Request for Additional Information No. 88 (1239, 1044), Revision 0

U. S. EPR Standard Design Certification

AREVA NP Inc.

SRP Section: 05.02.03 - Reactor Coolant Pressure Boundary Materials

Figure 05.02.03-12-1—CRDM Welds

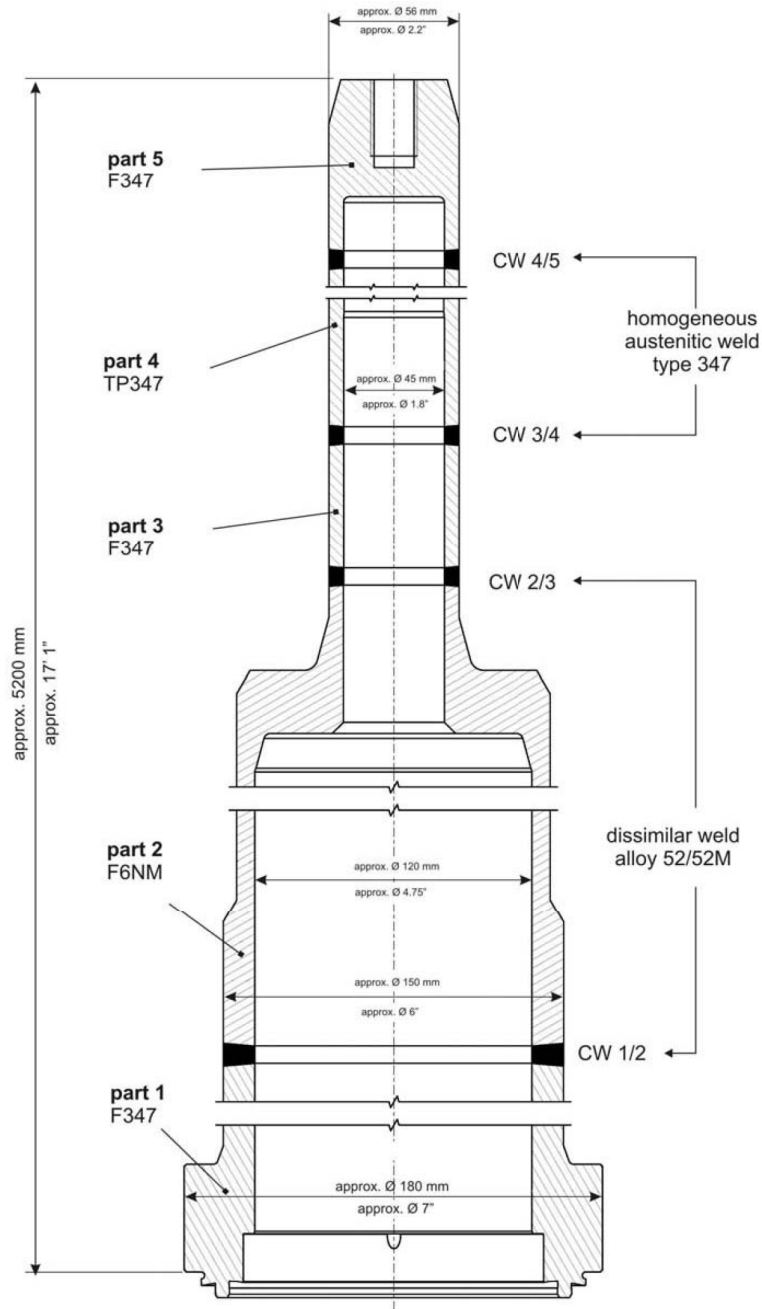
Table 5.2-2 indicates that Alloy 52/52M, Alloy 152 and Type 347 weld filler materials will be used in the fabrication of CRDM pressure housings. In reviewing the information provided in FSAR Sections 3.9.4, 4.5.1 and 5.2.3, the staff cannot identify where the CRDM pressure housing welds are located or what material/weld filler metal combinations are used. In order for the staff to continue its review, the staff requests that the applicant provide a description of the CRDM pressure housing welds including a detailed sketch that shows the locations of welds in the pressure housing and identifies the materials that are welded. In addition, provide a discussion of the weld joint designs, welding processes and heat treatment requirements that are used in the fabrication process.

The CRDM assembly is shown in Figure 05.02.03-12-1—CRDM Welds. The CRDM assembly has four welds, including two dissimilar welds using alloy 52/52M (ERNiCrFe-7/ERNiCrFe-7a) at locations CW 1/2 and CW 2/3, and two austenitic-austenitic welds (type ER347) at locations CW 3/4 and CW 4/5. As noted in Figure 05.02.03-12-1 and in U.S. EPR FSAR, Tier 2, Table 5.2-2, the pressure housing is fabricated as follows:

- The joints shown in Figure 05-02-03-12-1 are full penetration welds. The welds are made using the gas tungsten arc welding process.
- Joints CW 1/2 and CW 2/3 are full-penetration dissimilar metal welds that use Alloy 52/52M weld filler material and are welded with Alloy 690 backing rings. After welding, the backing rings are machined off when establishing the rough inside diameter bore dimensions.

- The lower pressure housing subassembly (part 1, part 2, and part 3) are heat treated in the lower-critical temperature regime of the F6NM alloy.
- The upper pressure housing consists of two austenitic stainless steel (F347/TP347) parts that are joined with a full penetration GTAW weld (CW 4/5) utilizing ER347 filler material. The upper and lower pressure housing subassemblies are joined with a full-penetration GTAW weld (CW 3/4) utilizing ER347 filler material. The joint (CW 3/4) is a similar metal joint between two austenitic stainless steels (F347/TP347).

The weld joint designs, welding processes, and heat treatment requirements for fabrication are developed later in the design process.
